WOLF CREEK NUCLEAR OPERATING CORPORATION

ET 05-0022

Subject: Docket No. 50-482: Response to Request for Additional Information – Reactor Coolant System Leakage Detection Instrumentation

RESPONSES TO REQUEST FOR ADDITIONAL INFORMATION

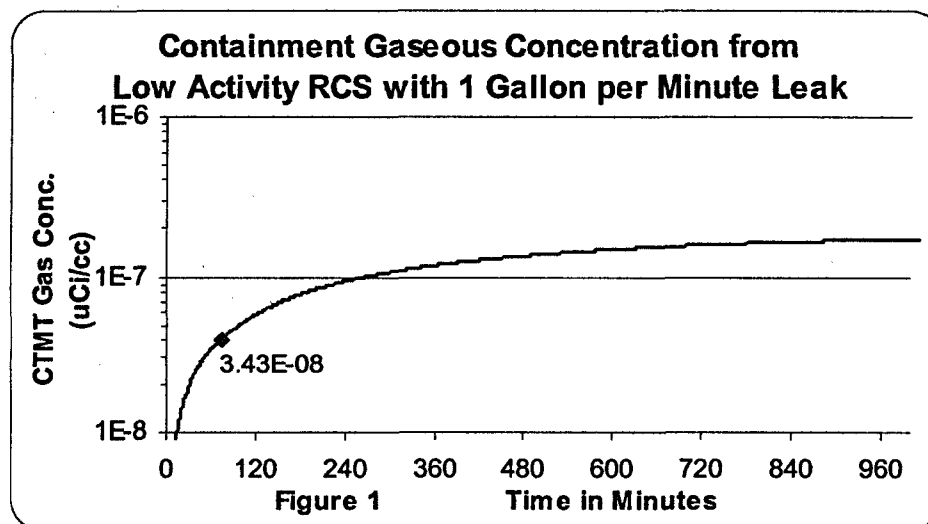
1. Given the discussion in the application on the containment atmosphere (gaseous) radioactivity monitor not being able to detect 1 gpm reactor coolant leakage in any way close to 1 hour for the current normal radioactivity levels in the reactor coolant, explain why this monitor is being retained in Limiting Condition for Operation (LCO) 3.4.15.

Regulatory Guide 1.45, "Reactor Coolant Pressure Boundary Leakage Detection Systems," defines the source term as: "In analyzing the sensitivity of leak detection systems using airborne particulate or gaseous radioactivity, a realistic primary coolant radioactivity concentration assumption should be used." The expected values used in the plant environmental report would be acceptable. The chart below provides a comparison of the RCS activity level during a period in 2003 to the values specified in the plant environmental report.

An evaluation performed in 2003 using current RCS activity levels resulted in a containment gaseous concentration at the end of 60 minutes to be $\sim 3.4\text{E-}08 \mu\text{Ci}/\text{cm}^3$ (see Figure 1 below). This evaluation confirmed the insensitivity of the containment atmosphere gaseous channels to low RCS activity.
